Submit I Cop Office	py To Appropriate District	State o	of New Me	xico		Form C-103	
	575) 393-6161	Energy, Mineral	ls and Natu	ral Resources		Revised July 18, 2013	
1625 N. French Dr., Hobbs, NM 88240					WELL API NO.		
<u>District II</u> - (575) 748-1283 811 S. First St., Artesia, NM 88210		OIL CONSERVATION DIVISION			30-025-37381		
<u>District III</u> – (505) 334-6178		1220 South St. Francis Dr.			5. Indicate Type		
1000 Rio Brazos Rd., Aztec, NM 87410		Santa Fe, NM 87505				X FEE	
<u>District IV</u> - (505) 476-3460 1220 S. St. Francis Dr., Santa Fe, NM 87505		Salita Pe, INIVI 67505		6. State Oil & Ga 301763	is Lease No.		
8/303	SUNDRY NO	TICES AND REPORTS (	ON WELLS		7. Lease Name of	r Unit Agreement Name	
DIFFERENT	SE THIS FORM FOR PROP RESERVOIR. USE "APPL	OSALS TO DRILL OR TO DE LICATION FOR PERMIT" (FO	EDENIAD DIT	BBS OCD	North Twinberry		
1	f Well: Oil Well	Gas Well 🛛 Other	,		8. Well Number	1

das wen Za other	11	JL 1 4 2020	9. OGRID Numb	er 256512	
2. Name of Operator CML Exploration, LLC			JOL 1 4 2020		9. GGRID Number 250512		
3. Address of Operator			DECENTED			10. Pool name or Wildcat	
P.O. Box 8	890, Snyder, Texas <i>7</i> 95	550	K	CEIVED	Vacuum; Mor	row

## CONDITIO

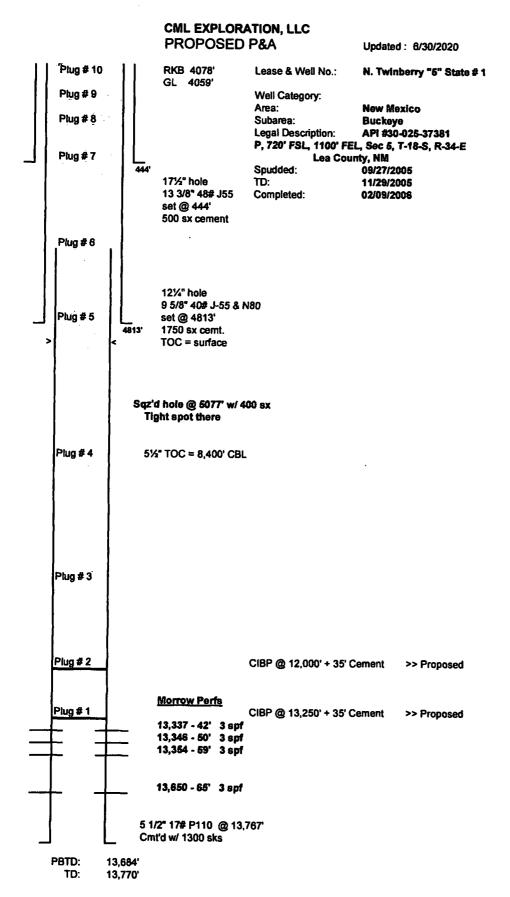
OTHER:  13. Desc of st prop Propose plug Circ Plug Plug Plug Plug Plug Plug Plug Plug	cribe proposed or completarting any proposed we consed completion or reconstant and abandon procedurate hole w/ 9.5 ppg m g # 1 – Set CIBP @ 13, g # 2 – Set CIBP @ 12, g # 3 – Spot 35 sx "H" of g # 4 – Spot 35 sx "H" of g # 5 – Spot 40 sx "C" of g # 6 – Spot 30 sx "C" of g # 7 – Spot 30 sx "C" of g # 8 – Spot 55 sx "C" of g # 9 – Spot 35 sx "C" of g # 9 – Spot 35 sx "C" of g # 10 – Circ to surface	oleted operations. (Clearly ork). SEE RULE 19.15.7 completion.  es as follows beginning Anud laden fluid.  250' + 35' "H" cement or 000' + 35' "H" cement or cement 10,000 – 9700' (Verent 8,800 – 8500' (Abordent 5127 – 4763' (square casing cement 3050' – 2900' (casement 2650 – 2450' (basement 1750 – 1550' Rusterment 1200 – 1100'	August 2020: In top. In top. Volfcamp) In top. Volfcamp In top. V	rtinent details, and For Multiple Com  2 9 5/8" casing show	See Attach we See Attach we See Attach we Conditions of the Condit	ellbore diagram of

- 17. A CIBP is to be set within 100' of production perforations, capped with 100' of cement, WOC 4 hours and tag.
- 18. A CIBP with 35' of cement may be used in lieu of the 100' plug if set with a bailer. This plug will be placed within 100' of the top perforation, (WOC 4 hrs and tag).
